SAFETY RECALL

Date	Number	Release	Page
09.2024	SC0469	01	1(8)

Rolltek Seat Installation AN, GR, PN

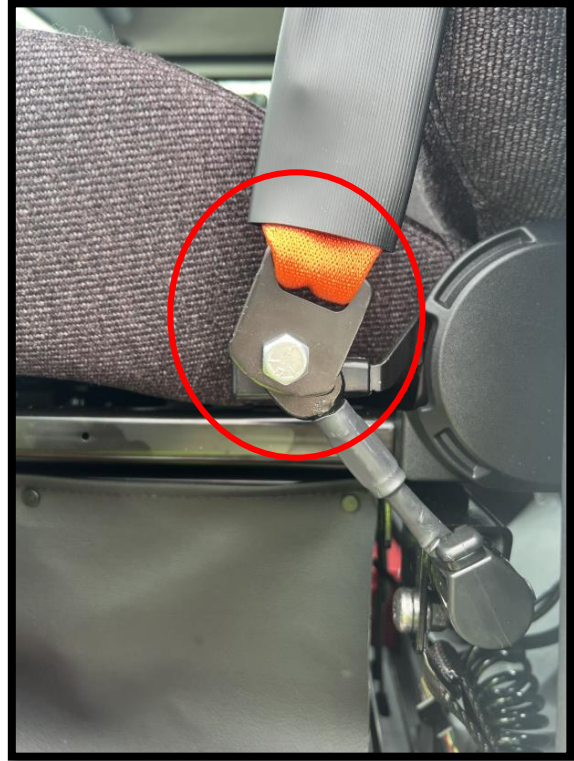
7. Locate, replace, and torque the two tether bolts attached to the cab floor behind the seat and torque to 65 Nm.

Tightening Torque
65 Nm

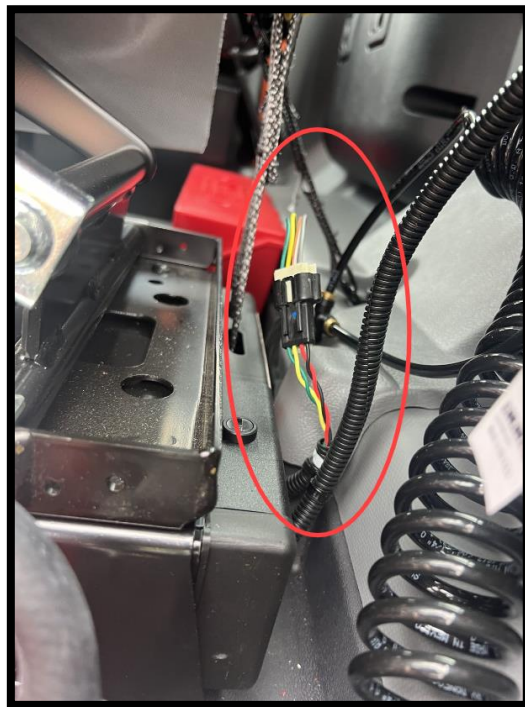
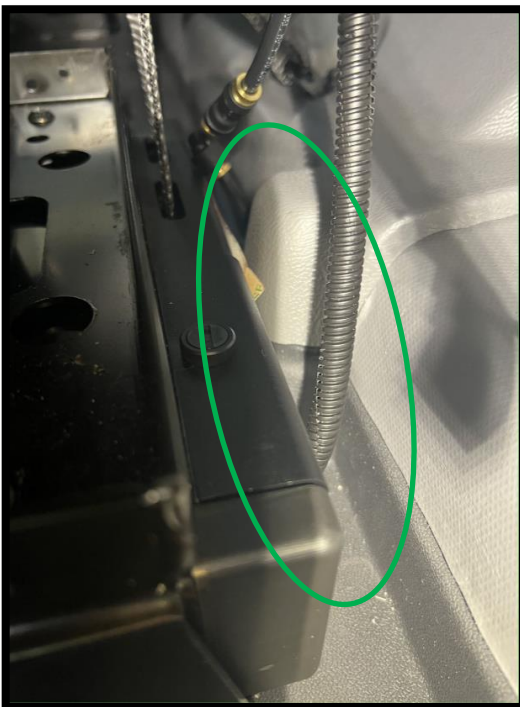
8. Replace the seat belt bolt ensuring that the mounting tab is angled towards the driver. Torque to 55 Nm.

*Angled towards driver

*Angled away from driver

Tightening Torque
55 Nm

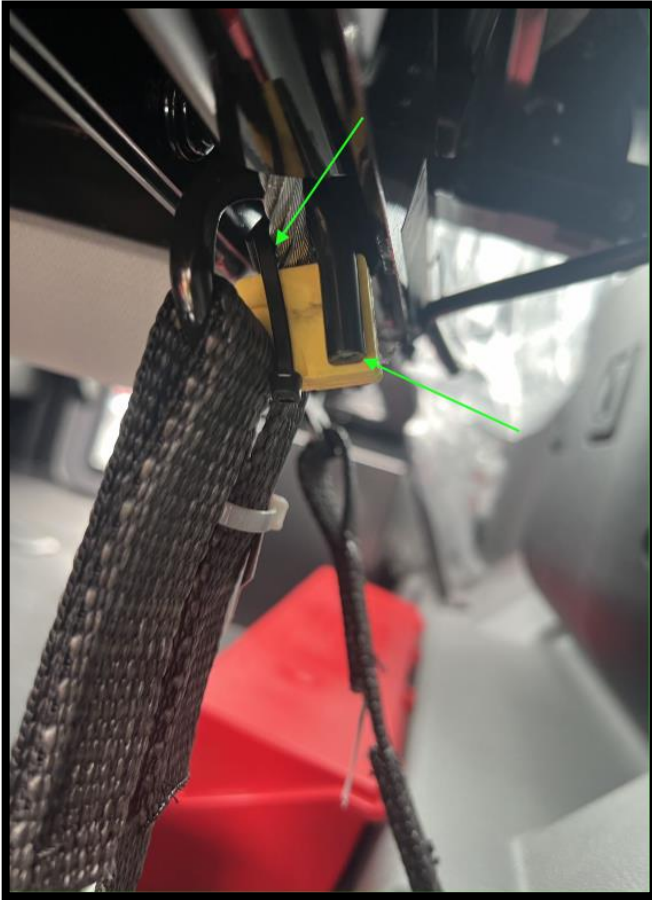
9. Wires should be secured in the box at the bottom backside of the seat. Secure wires inside if they are found outside of the box.

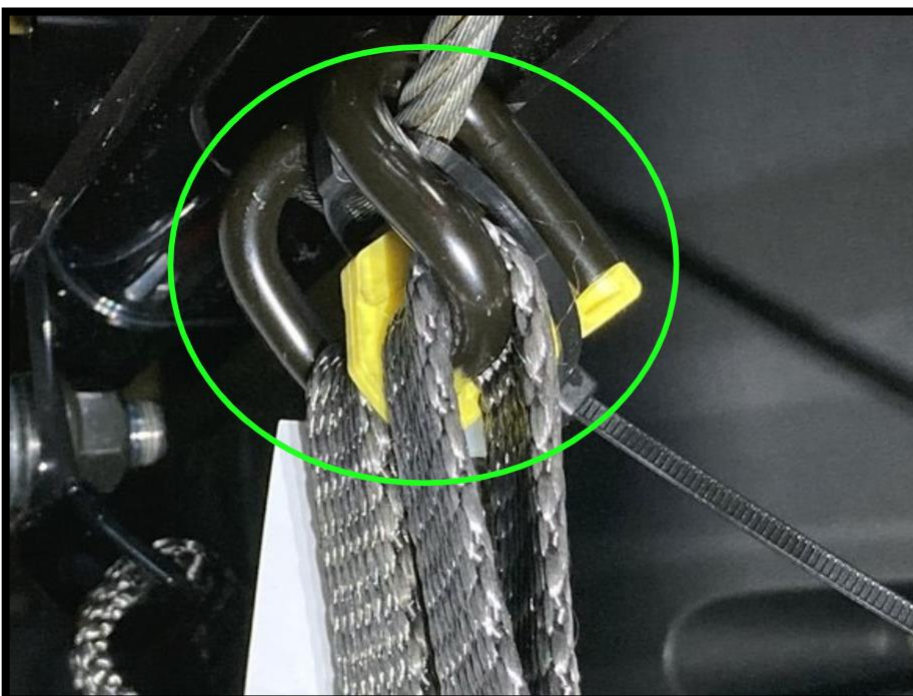
10. Check that the yellow locking tab is fully engaged between the metal hooks and zip tie is fed through the plastic housing on the cable to secure the yellow tab.

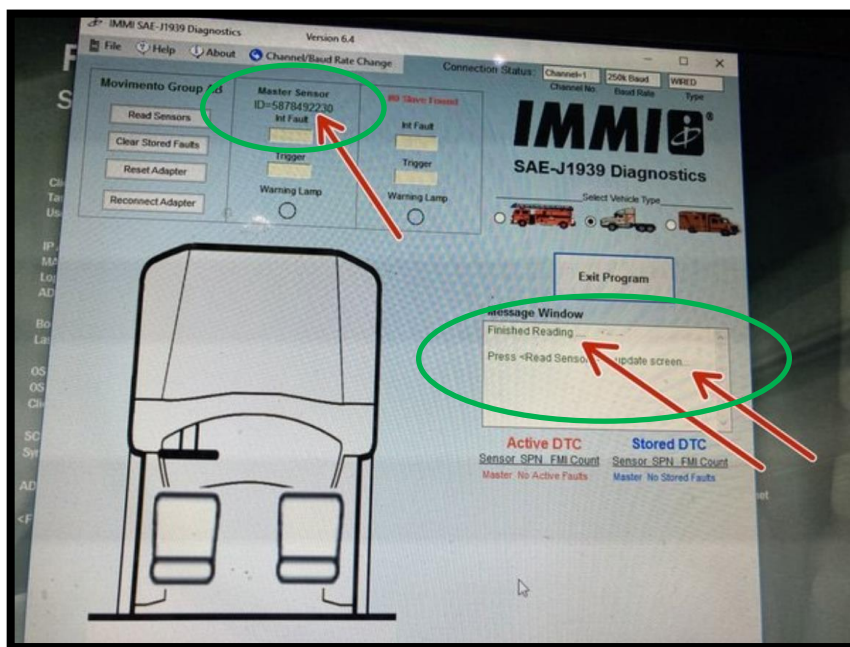
14. Plug computer into OBD port and run the diagnostic test. All three illustrations shown below should be green if RollTek seat is functioning properly. Ensure any stored DTC's are cleared.

- a. If you have active DTC's, follow the troubleshooting guide found on the link provided.
- b. If no active DTC's are present, unhook service tool and return truck to service.
